Power Converter Box Grounding

Date: March 12, 2009

Applies to: All C5500, W-5, and F-650 Company Stores built before March 6, 2009.

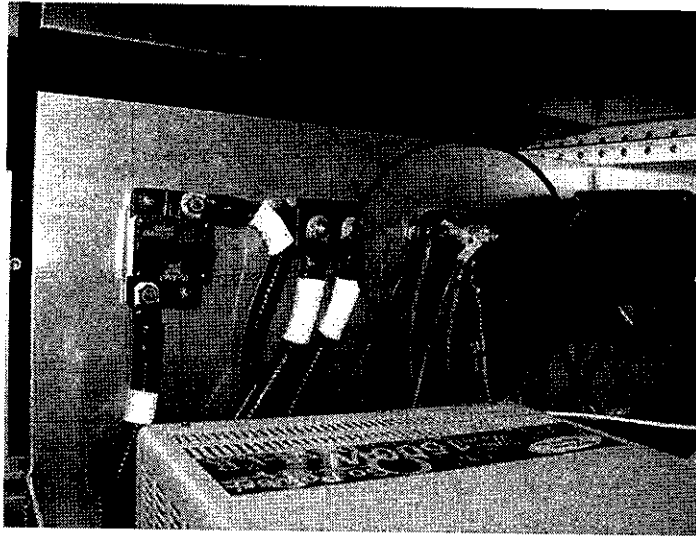
The aluminum box that contains the power converter, inverter, isolator, and associated hardware is not fully grounded. This can be corrected by replacing the insulated ground stud with an un-insulated stud.

- b. On C5500 and F-650 models this is located on the driver's side, opposite of the batteries. This panel is also attached with hook-and-loop (commonly known as Velcro™).
5. Locate and remove the insulated ground stud.

6. Install the un-insulated stud. The mounting pattern is the same and should install exactly as the insulated one using the same hardware. Ensure all ground cables that were previously on the ground stud are replaced on the new stud.
 7. Replace the carpeted/vented panel for the power converter box.
 8. Replace the negative cable on the battery.
 9. Replace the carpeted battery compartment access panel.
